Comments on Planning Application HGY/2022/0356 – 22 Colney Hatch Lane

We are the owner-occupiers of No.20 Colney Hatch Lane, London, N10 1DU. We are the immediate neighbours to the south of the property in relation to which this planning application has been made.

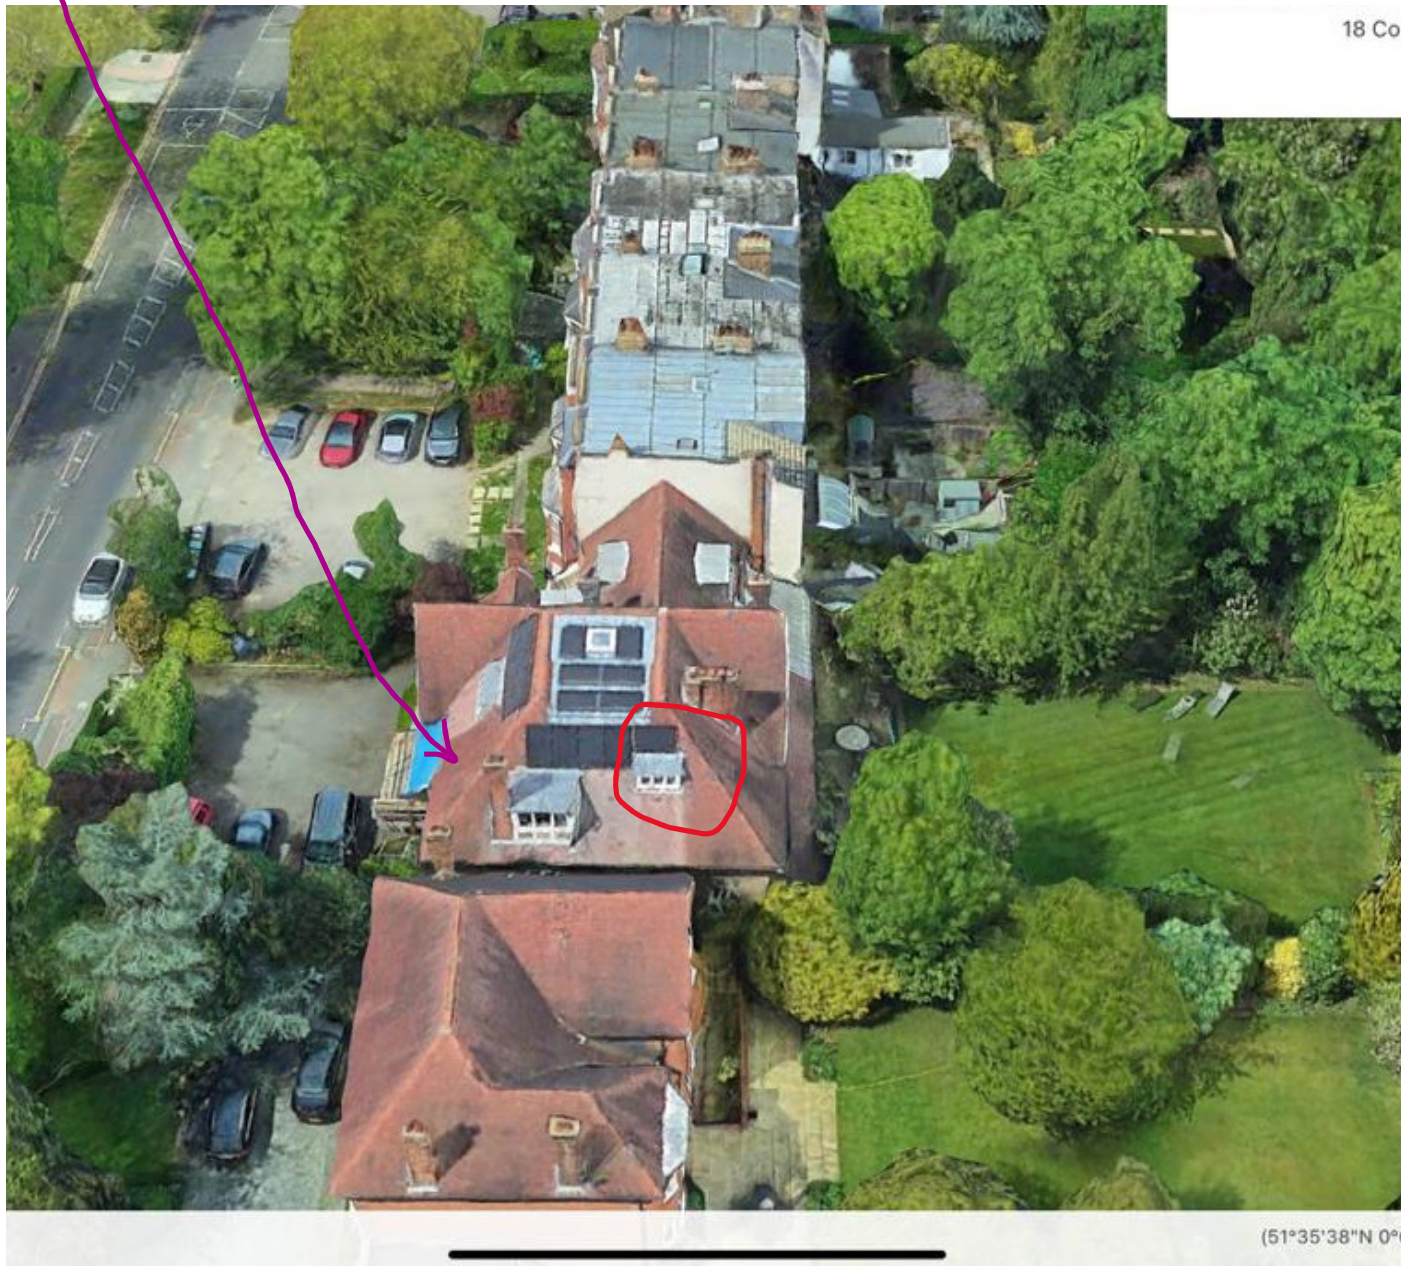
We take issue with the accuracy of the plans submitted by the applicant's advisers, Peter Brades Architects. Side Elevation as Exists 1745/07 shows incorrectly the existing dormer window as touching or nearly touching the existing roof side ridge line. This was not the case – the former existing window was about 1-2m away from the roof side ridge line. We attach Photos 1 and 2 that clearly show the position of the original window.

Photo 1 (**dormer window before works** – it is about 1-2m away from the roof side ridge line; there was no direct view of our terrace; no window facing our property on No.18)

Photo 2 (dormer window before works – it is about 1-2m away from the roof side ridge line; chimney stack which has been removed with consent and without being included in retrospective application)

Photo 3 (dormer window after unauthorised works – it is now touching the roof side ridge line and does not have leaded glass windows)

Photo 4 (side elevation windows that have been replaced with plain glass panels instead of lead latticing)

We therefore request that the enlarged dormer window is replaced to take it back to its original position, proportions and features. Alternatively, we request that, out of the five panels of the dormer window,

Copy of Front Elevation as Exists 1745/06 on which we have marked up the chimneys that have been removed without consent

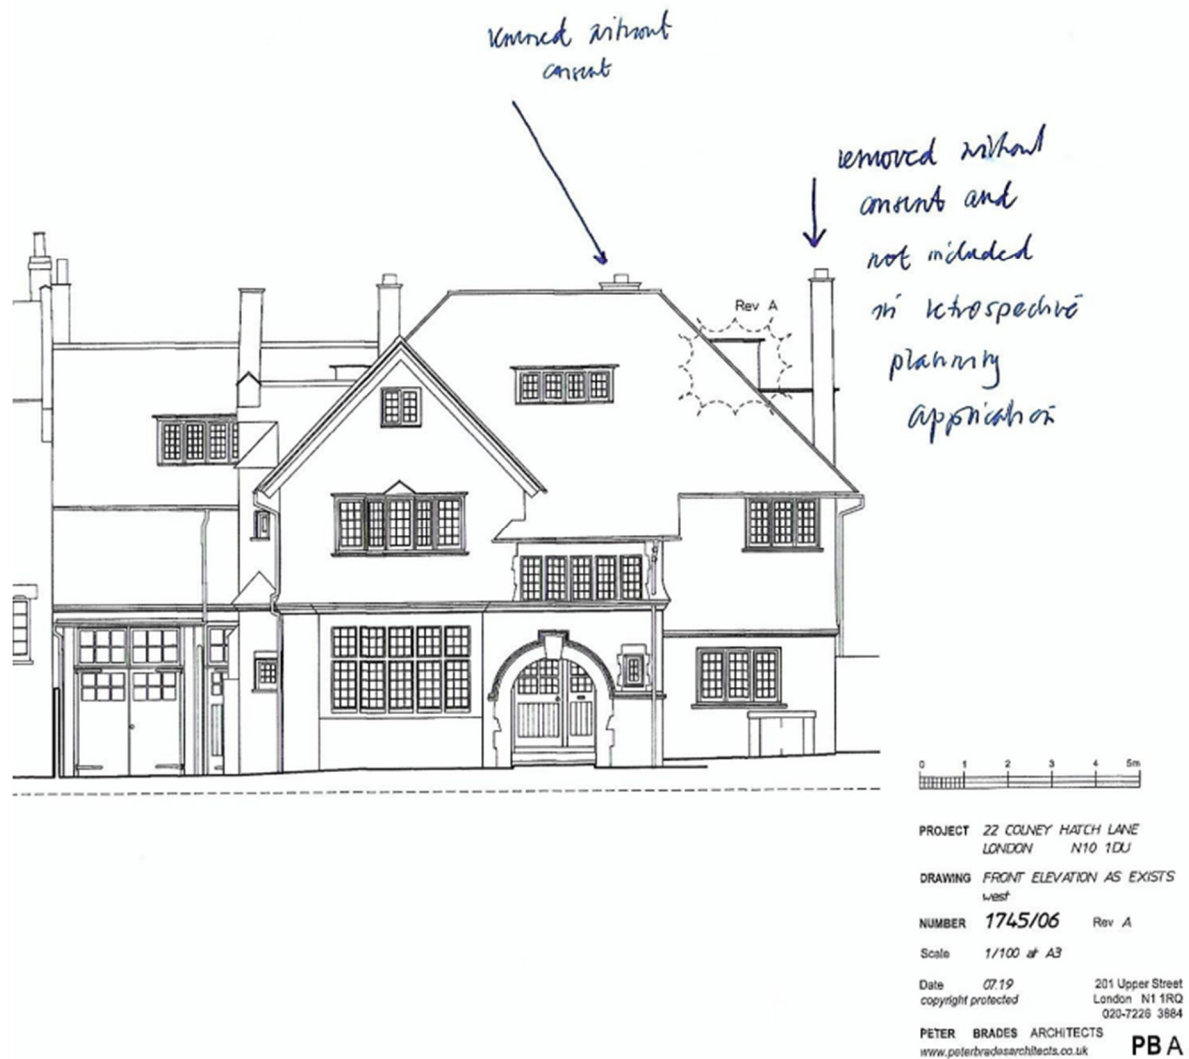
Neither the retrospective planning application nor the plans 'as proposed' indicate that another chimney at the front of the house (left to the smaller dormer window in drawing of 2nd Floors as Exists 1745/05; and at the far right in drawing of Front Elevation as Exists 1745/06) has also been removed without consent. We attach a copy of drawing Front Elevation as Exists 1745/06 on which we have marked up the chimneys that have been removed without consent. We also attach a photo taken a few days ago showing the absence of those chimneys (Photo 5).

The applicant is applying for planning permission for the removal of a chimney at the back. The applicant has failed to include into his application that another chimney has been removed for which no prior planning consent had been given. Both chimneys were prominent external features of the architectural style and detail of the original building which itself is part of the character of the area (see attached copy of drawing Front Elevation as Exists 1745/06 on which we have marked up the chimneys that have been removed without consent). Both of the chimneys which have been removed were visible features from the front view of the property. Photo 5 shows the absence of those chimneys, and it also shows that the chimneys are prominent architectural features in neighbouring properties.

We also reiterate that the chimney at the front of the house has been removed without planning permission and has not been included in the current retrospective planning application – as such it should continue to be subject to the planning enforcement investigation and should be reinstated.

Photo 5 (taken a few days ago, showing absence of front right chimney at the front of the house has been removed without planning permission and has not been included in the current retrospective planning application. The photo also shows that chimneys are prominent architectural feature of the neighbouring properties)

We therefore request that both chimneys in question are reinstated, all windows facing our property and all windows at the front of the development are replaced with lead-panelled windows to match the originals, and that the enlarged dormer window is replaced to take it back to its original position, proportions and features.
